Access Compliance Report

Public Rights-of-Way

Intersection ID: 12278	Main Street: SEIGLE_AV	Cross Street: VAN_EVERY_ST	Location:	N
ADA ID: 72B7E5D3A2EF	Ramp Type: Perp	Initial Pass/Fail: Fail	Overall Compliance: No	Severity Score: 25

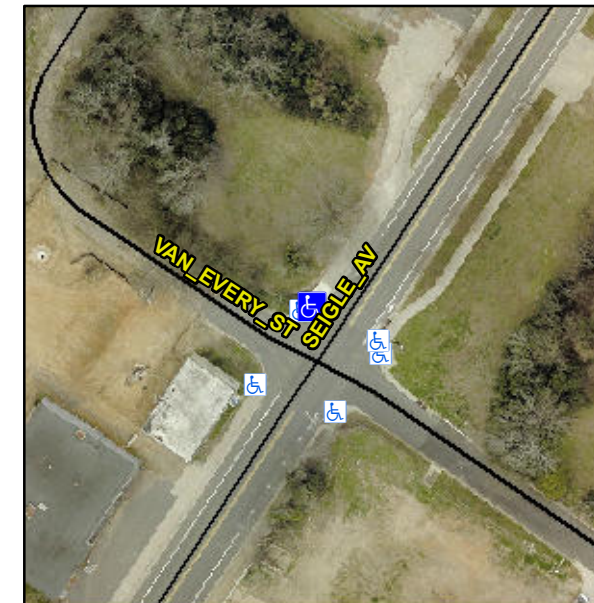
Not Found, R304.5.3

Compliance	Description	Data	Compliance	Description	Data
N/A	Ramp Length (in)	52.5	Yes	Ramp Slope (%)	5.8
Yes	Ramp Width (in)	48.0	No	Ramp XSlope (%)	8.1
N/A	Flare Type LT	N/A	N/A	Flare Type RT	N/A
N/A	Flare Slope LT (%)	N/A	N/A	Flare Slope RT (%)	N/A
N/A	Flare Traversable LT?	N/A	N/A	Flare Traversable RT?	N/A
N/A	Landing Length (in)	N/A	N/A	DWS Provided?	N/A
N/A	Landing Width (in)	N/A	N/A	DWS Contrast?	N/A
N/A	Landing Slope (%)	N/A	N/A	DWS Length (in)	N/A
N/A	Landing X Slope (%)	N/A	N/A	DWS Full Width?	N/A
N/A	Landing Curb? (Y/N)	N/A	N/A	DWS Offset (in)	N/A
N/A	Shared Landing?	N/A			
N/A	Gutter Ponding?	N/A	N/A	Gutter Slope (%)	N/A
N/A	Gutter Lip Ht (in)	N/A	N/A	Gutter X Slope (%)	N/A
N/A	Painted X Walk1?	No	N/A	Painted X Walk2?	N/A
	X Walk 1 Direction	To SE		X Walk 2 Direction	N/A
N/A	X Walk 1 Width (in)	N/A	N/A	X Walk 2 Width (in)	N/A
	X Walk 1 Slope (%)	3.4		X Walk 2 Slope (%)	N/A
	X Walk 1 X Slope (%)	4.1		X Walk 2 X Slope (%)	N/A

Remove & Replace Entire Ramp.
